Addendum #2 to the Technical Drainage Study for

AREA 15 DISTRICT 2

Date Prepared:
February 2023

GRADING PLAN - SHEET 4

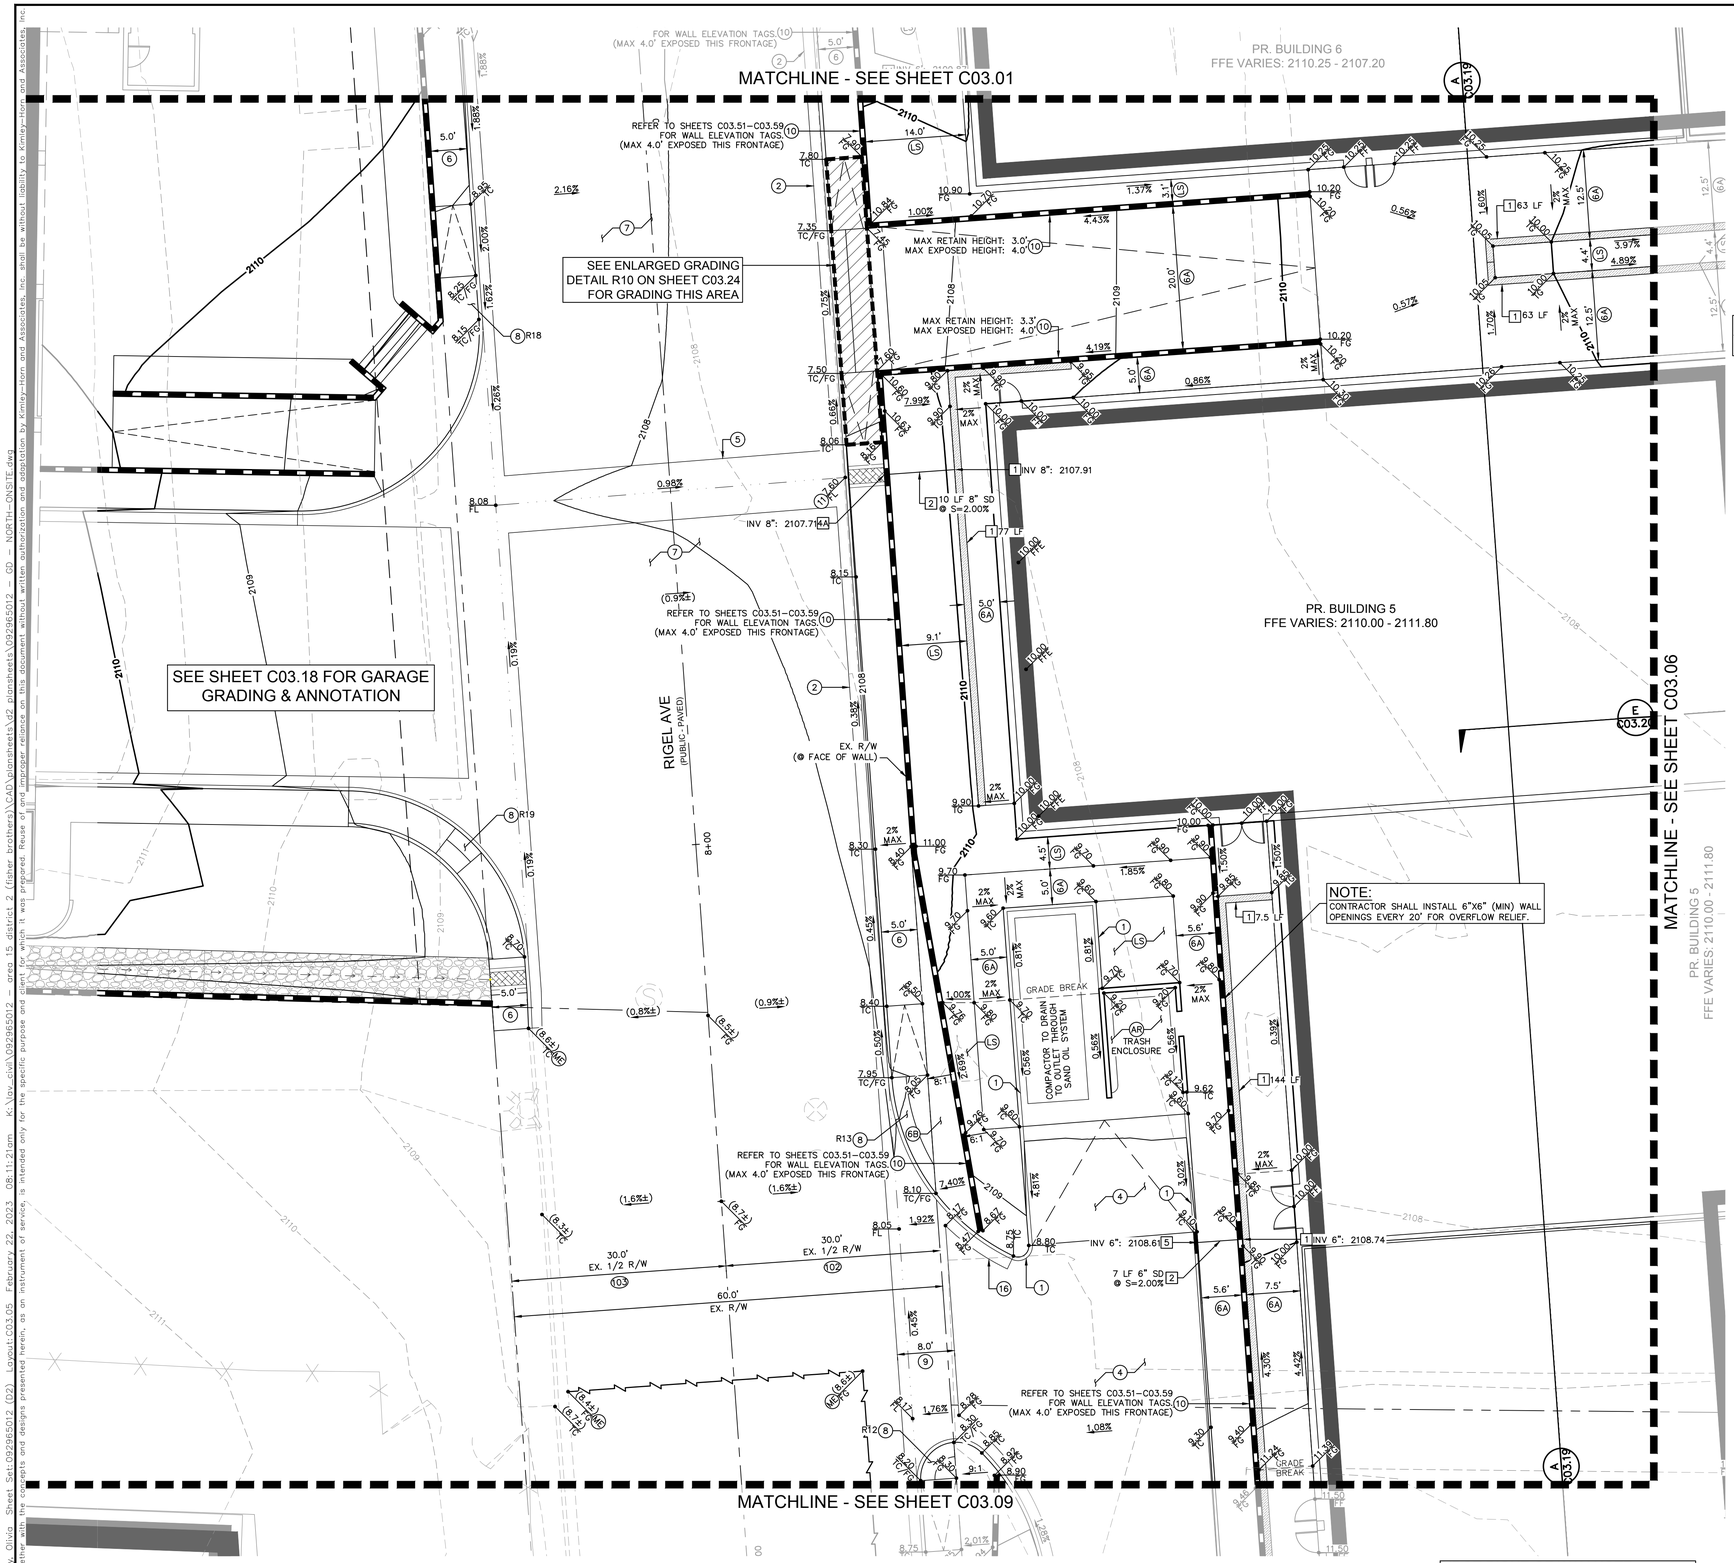
10. **Sheet C03.04:** There is a pond being created at the northeast wall of the trash enclosure. Review and revise accordingly.
11. **Previous Comment 10:** Provide flow slopes throughout the site for the proposed pipe and trench drains to verify pipe and trench flow capacity.

Comment 10: **Sheet C03.04: There is a pond being created at the northeast wall of the trash enclosure. Review and revise accordingly.**

Sheet C03.04: The proposed driveway access at Rancho Drive is humped 6-inches above the WSE in the street looking both north and south along the driveway. Additionally, solid grouted walls have been provided for **PR Building 1** (Refer to Response to Comment #2) along Rancho Drive. It is understood that the 100-year water surface elevation will inundate the driveway, and pedestrian ramps to the north, but will not impact the proposed **PR Building 1**. Please refer to the improvement plans in **Appendix C**.

18 OF 57 SHEETS
C03.05

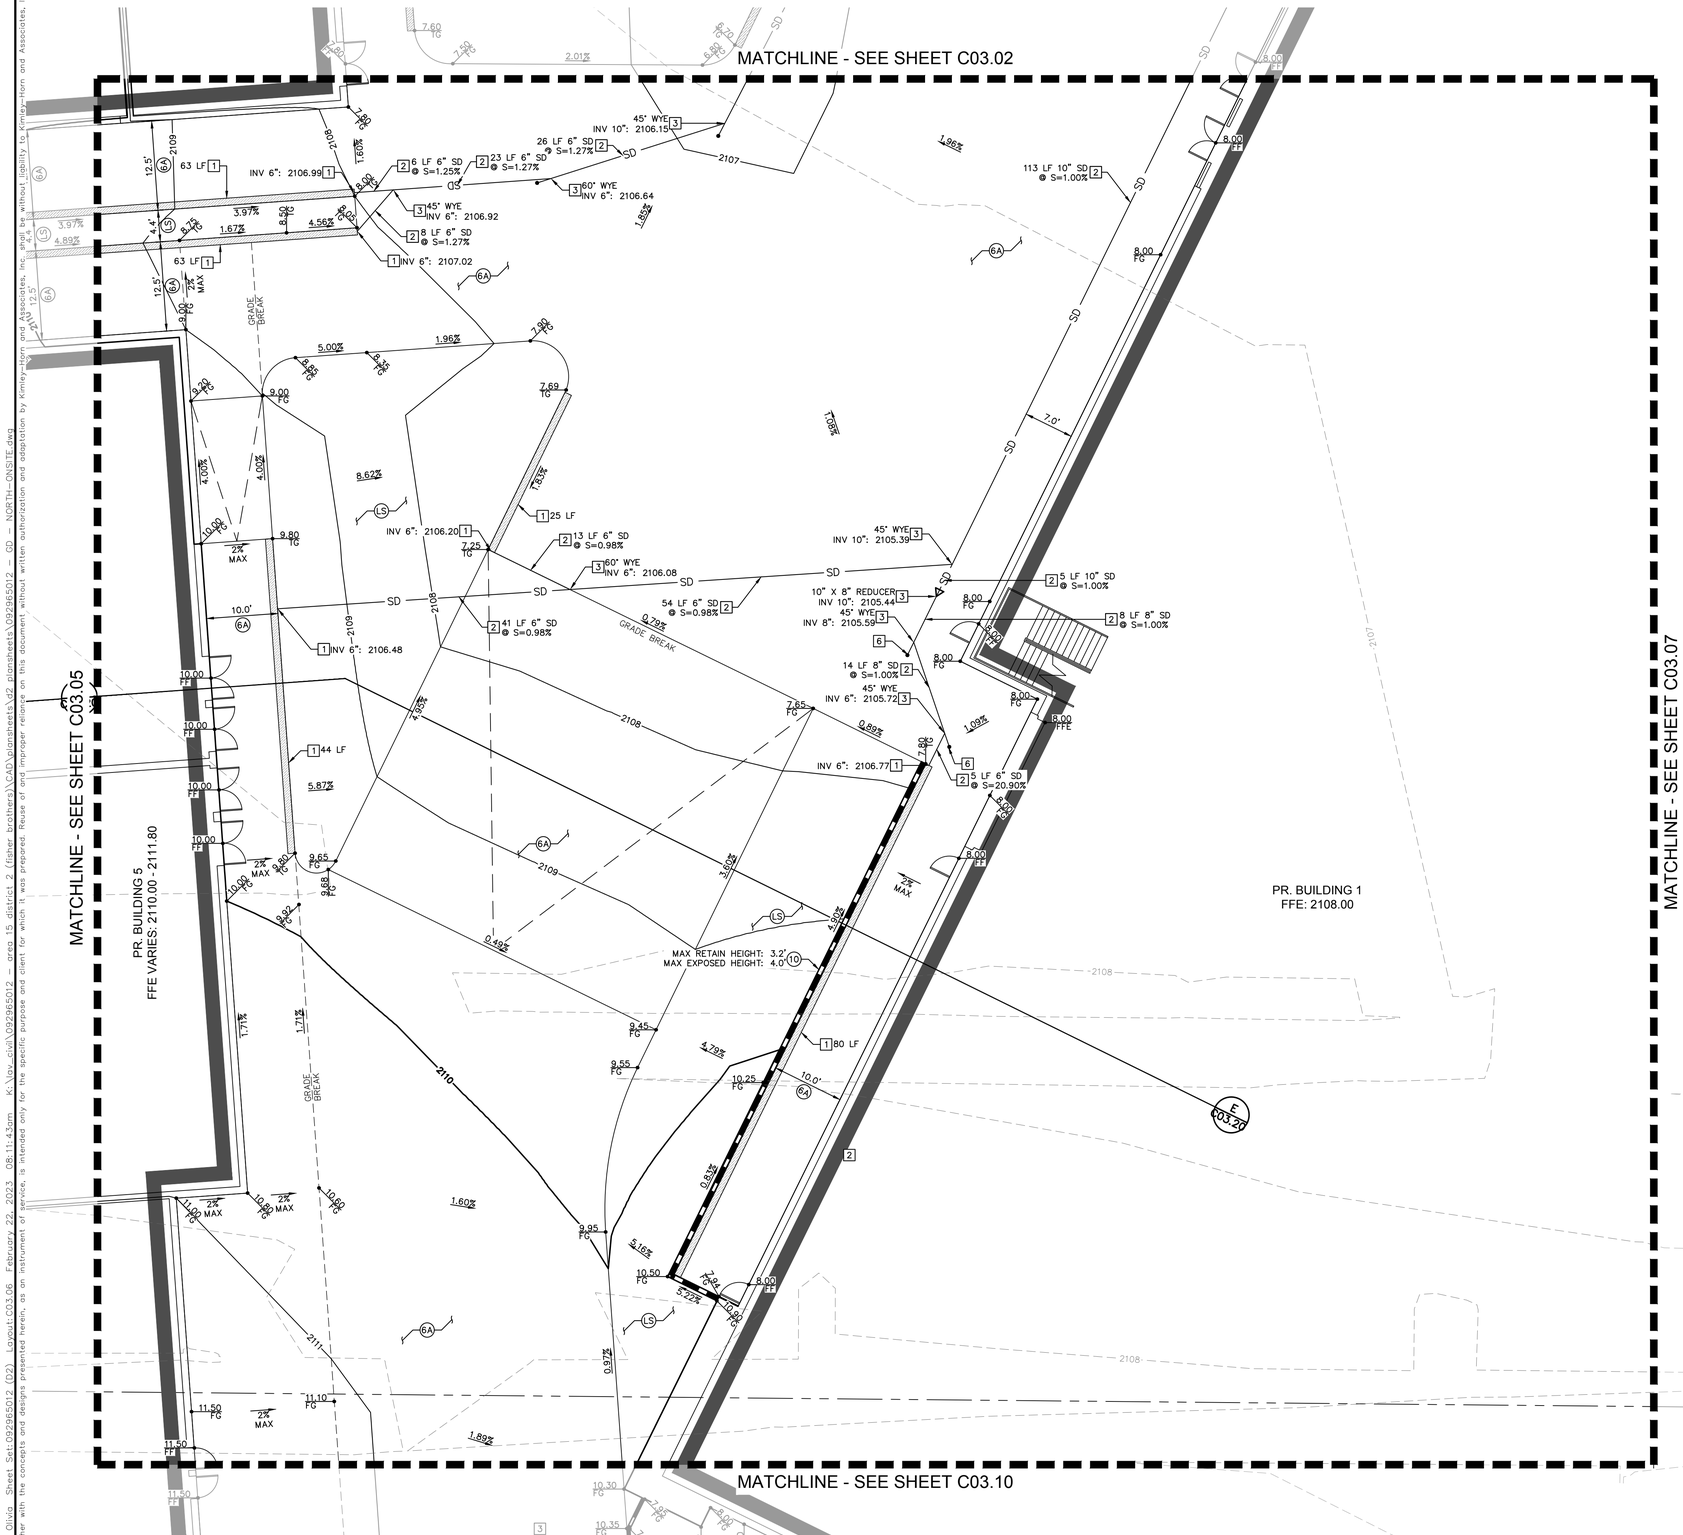
Comment 4: **Sheet C03.04, C03.05, & C03.15: Explain what will happen when the walls break for a ramp up to the buildings, what protection is offered for these buildings.**

Sheet C03.05: The proposed pedestrian access Ramp 10 at Rigel Avenue is humped 6-inches above the WSE in the street. The proposed driveway access at Rigel Avenue is also humped 6-inches above the WSE in the street. Additionally, the **PR Building 5** finished floor elevation is set above twice the depth of flow in the adjacent roadway along Rigel Avenue. Please refer to the improvement plans in **Appendix C**.

19 OF 57 SHEETS
C03.06

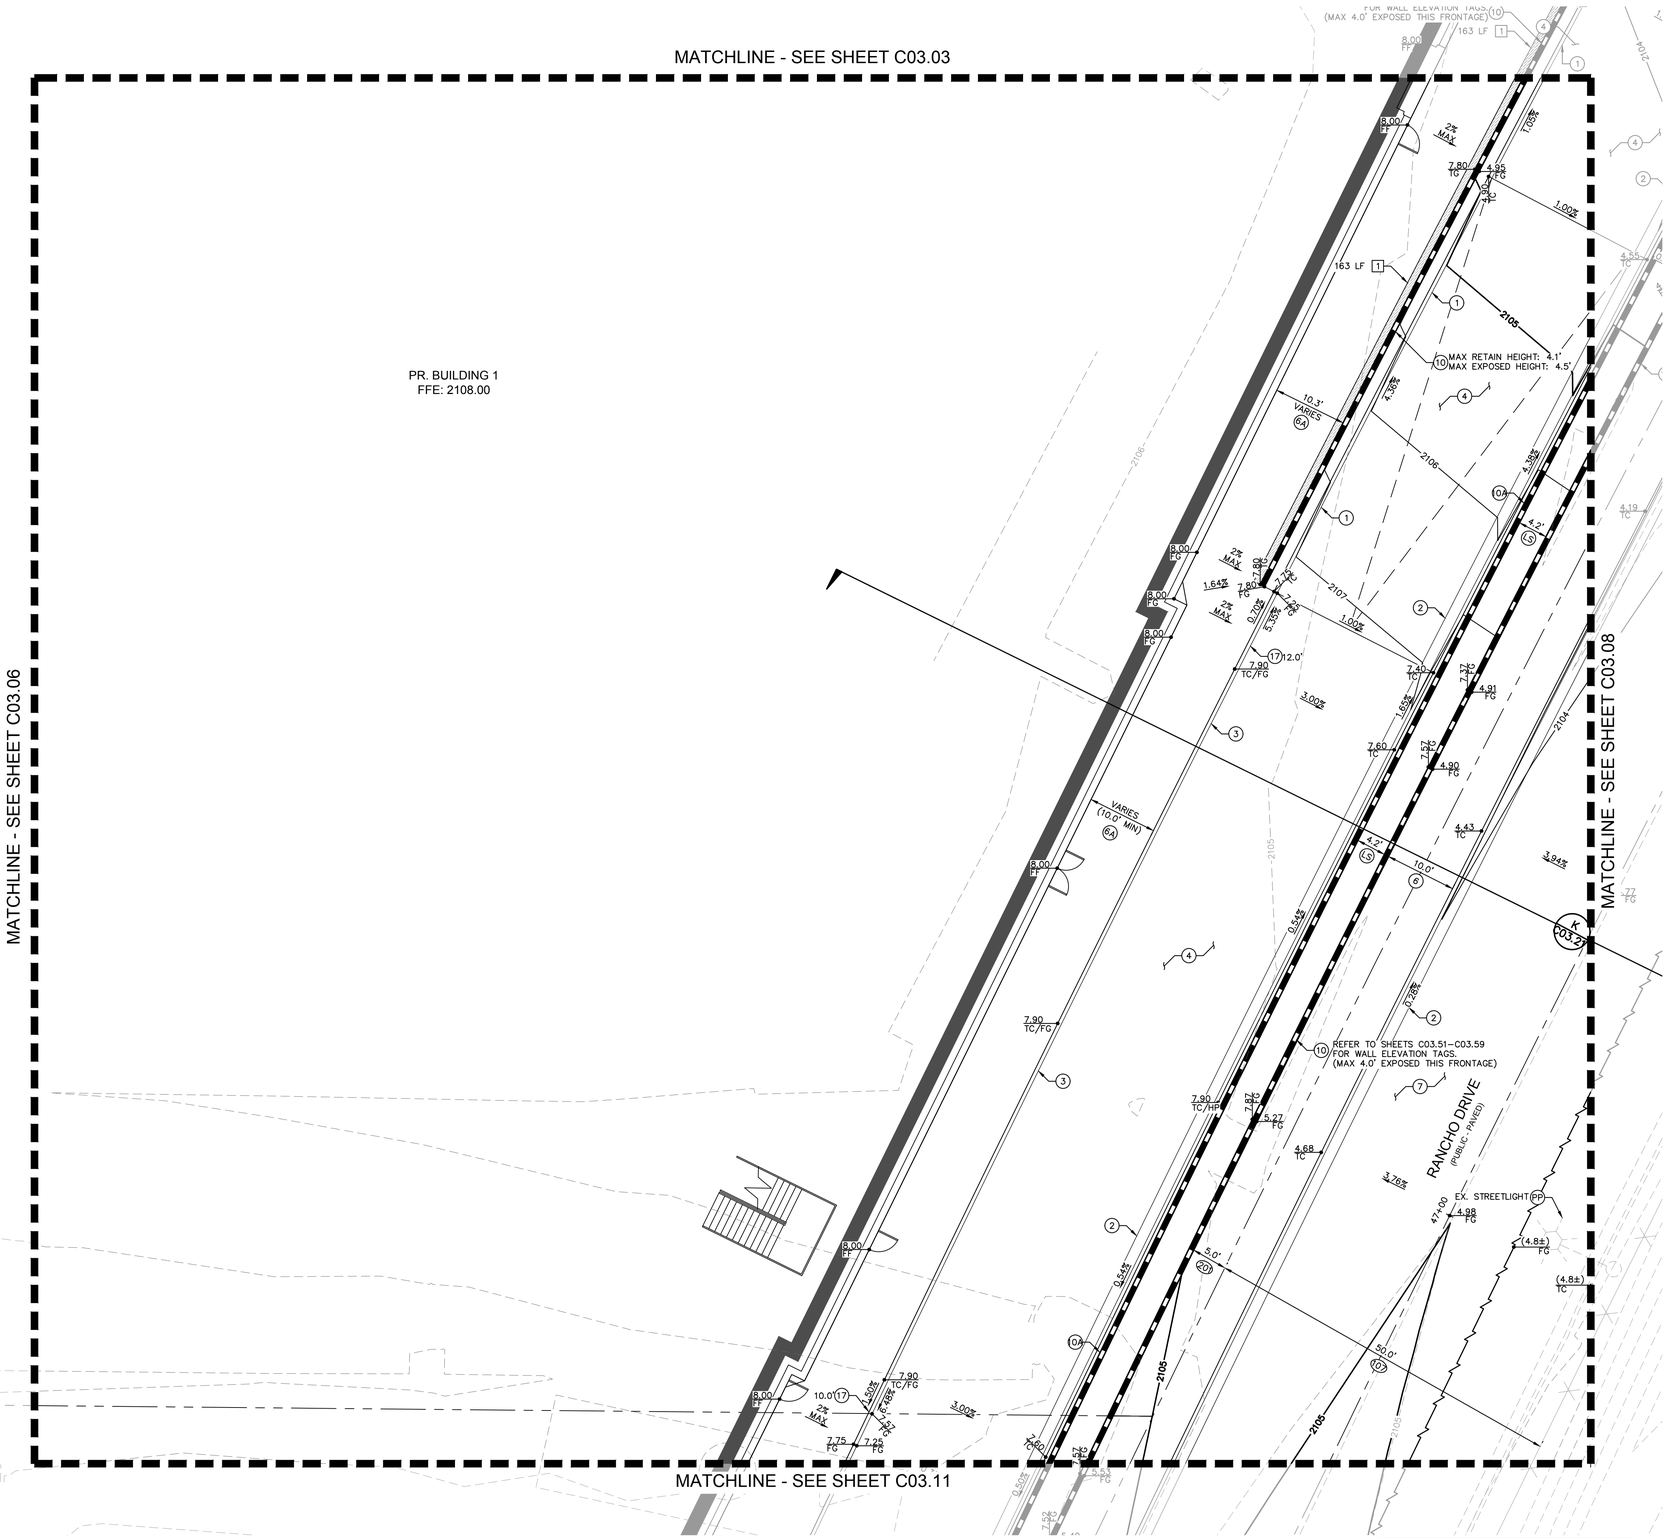
9. **Sheets C03.06 & C03.10:** Provide a wall at the southwest corner of PR Building 1 to connect the north and south walls to prevent onsite flow from reaching the building and to protect against the emergency overflow of Trench ONG #1.

Comment 9: **Sheet C03.06 & C03.10: Provide a wall at the southwest corner of PR Building 1 to connect the north and south walls to prevent onsite flow from reaching the building and to protect against the emergency overflow of Trench ONG #1.**

Response: Per a phone conversation with CLV on February 13, 2023, the north and south walls at the southwest corner of **PR Building 1** have been connected to the building as shown on **Sheet C03.06** and **C03.10** to prevent emergency overflows from Trench ONG #1 from impacting the PR Building 1. Refer to the improvement plans in **Appendix C.**

GRADING PLAN - SHEET 11

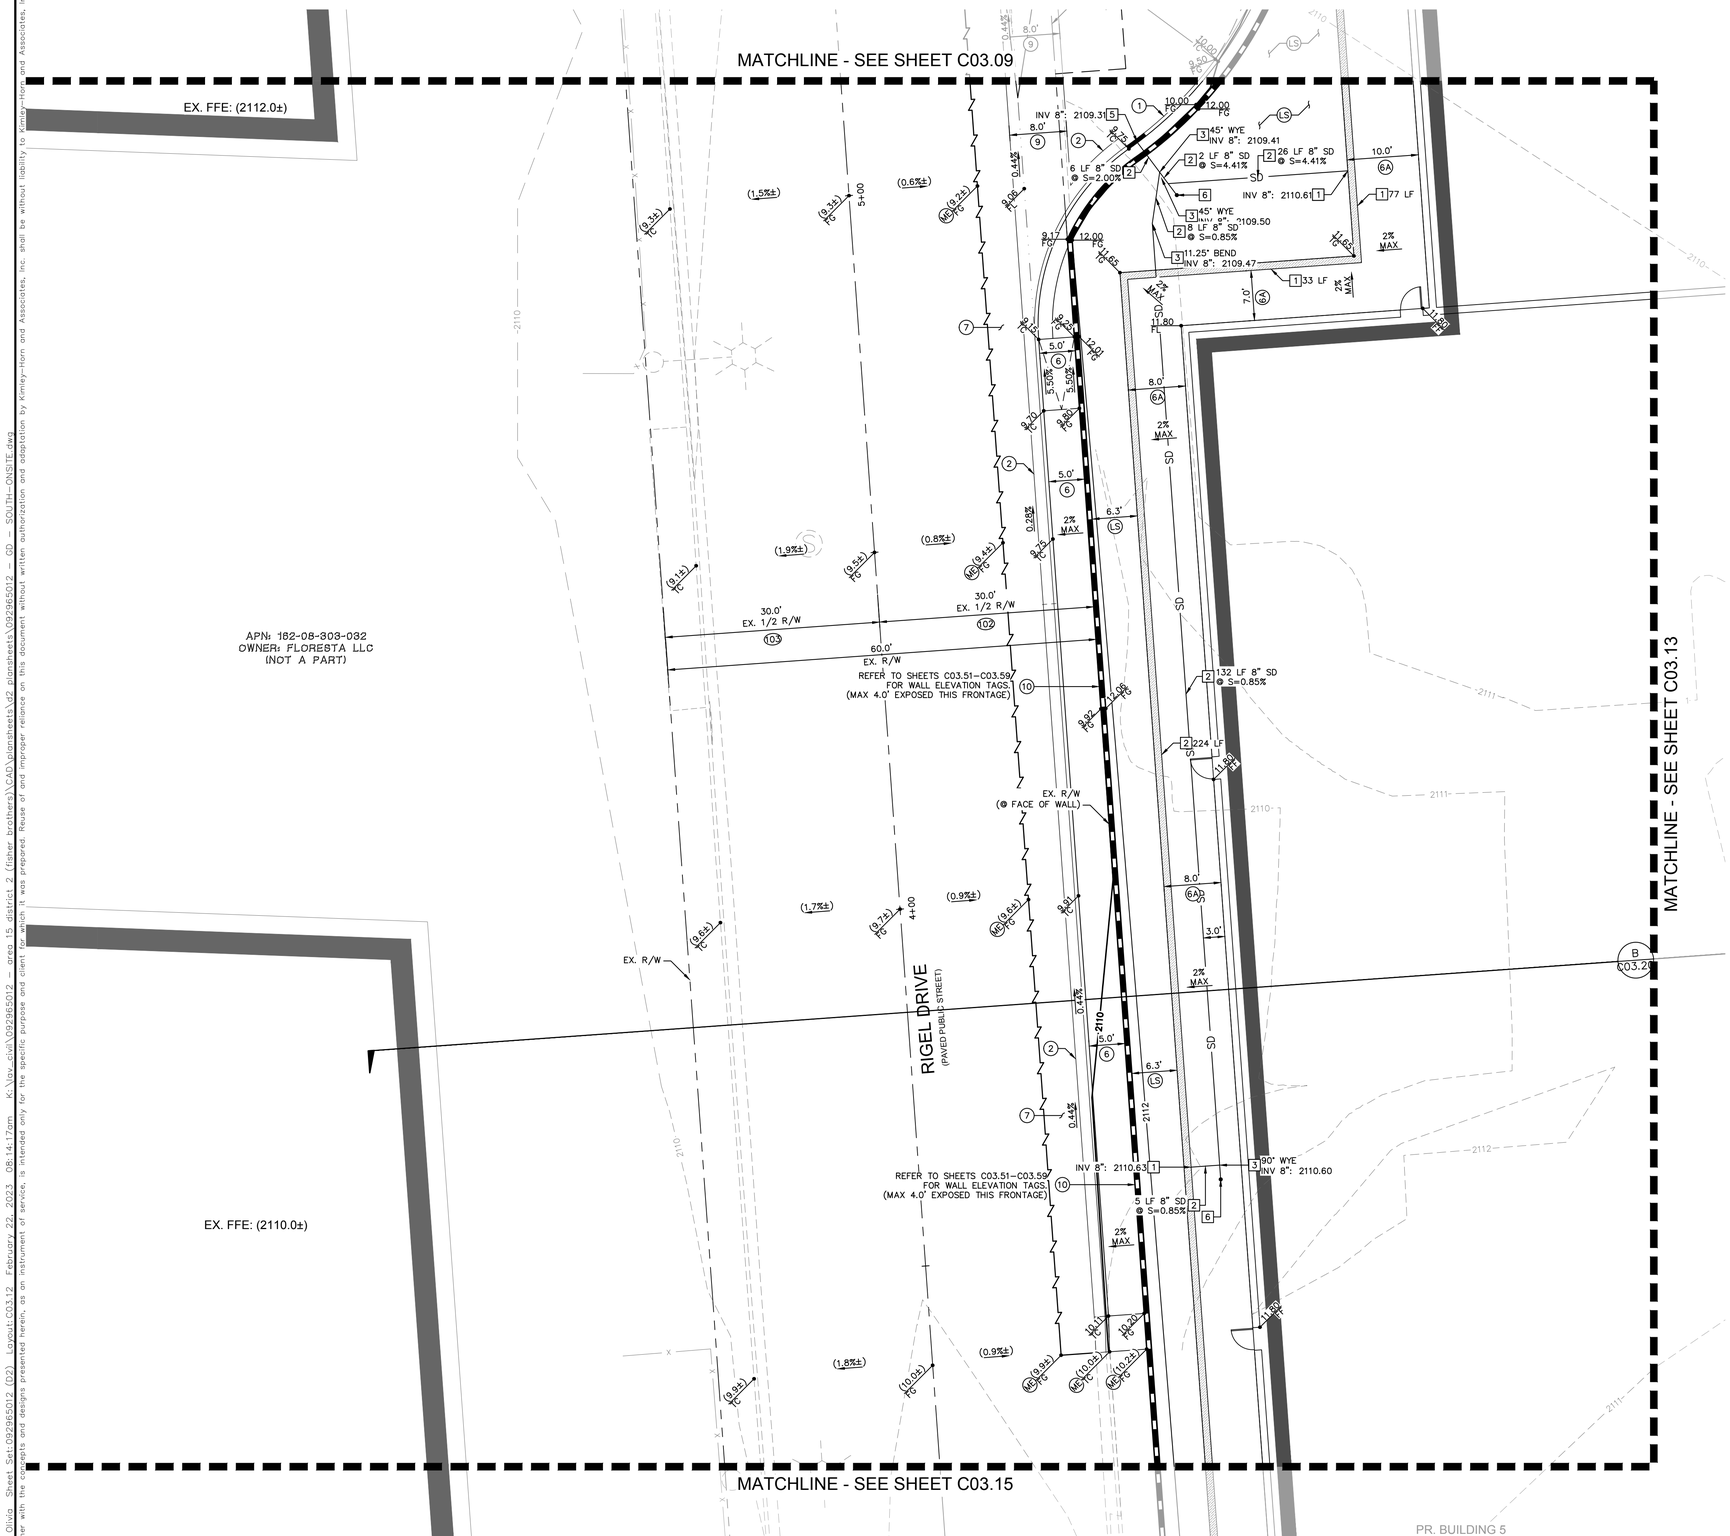
8. **Sheet C03.10 & C03.11:** In the OUTDOOR PATIO/STORAGE AREA, adjacent to the south of PR Building 1, there is a trench drain collecting onsite flow, Trench ONG#4. From the grading it appears Trench ONG#4 has no clear escape in an emergency situation. Show greater detail in this area or provide a pathway of escape.

Comment 8: **Sheet C03.10 & C03.11: In the OUTDOOR PATIO/STORAGE AREA, adjacent to the south of PR Building 1, there is a trench drain collecting onsite flow, Trench ONG#4. From the grading it appears Trench ONG#4 has no clear escape in an emergency situation. Show greater detail in this area or provide a pathway of escape.**

Response: As discussed in a meeting with CLV on February 13, 2023, a gate has been added to **Sheet C03.11** to provide an emergency overflow path for the Outdoor Patio/Storage Area in the unlikely event the **Trench Drain ONG#4** becomes completely clogged. Please note that this is an emergency overflow condition only and the proposed system is designed to intercept and convey all onsite nuisance and storm flows up to a 100-year storm event. Refer to the improvement plans in **Appendix C**.
